**HYDRO-QUÉBEC DISTRIBUTION RESPONSES TO
QUESTIONS FROM PARTICIPANTS**

1 **Figure 1: Number of Meters Replaced Annually in the Reference Scenario (in**
 2 **Thousands of Meters)**

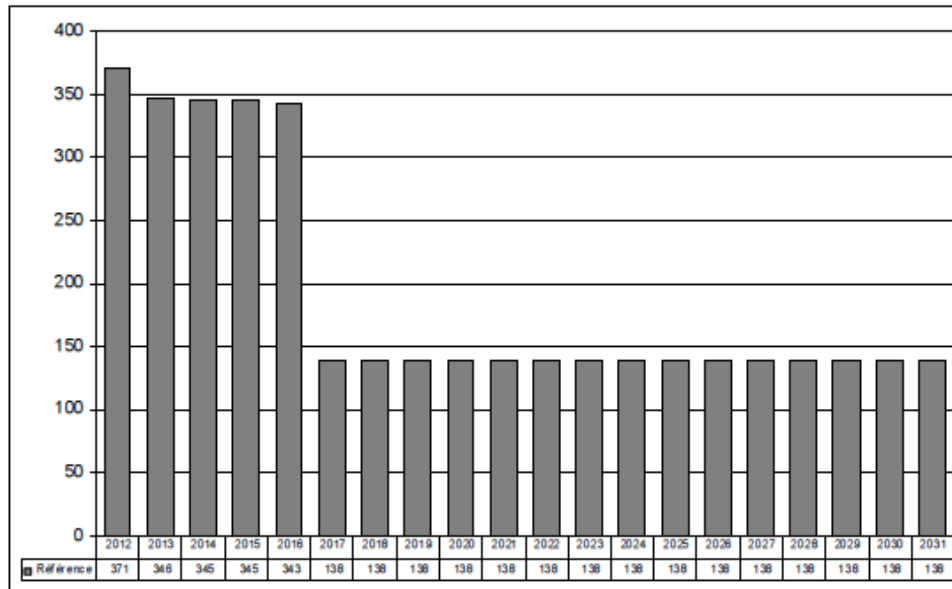
The age of the devices in the current embedded fleet, and the implementation of the new standard have increased the risk of rejected lots for a significant number of devices. In order to properly manage this risk and to level out the work load, the current meter replacement strategy called for in the reference scenario over the next five years is essential. This proactive management will make it possible to subsequently make the annual meter replacements uniform from 2017 to 2031. The Distributor has produced the following graph⁸ in order to make it easier to read the reference scenario meter replacement rate.

As the Distributor indicates at the end of section 2.2.3 of the present document, even if the reference scenario was based on a uniform replacement rate over 20 years, the economic analysis would still show significant savings for the AMI scenario.
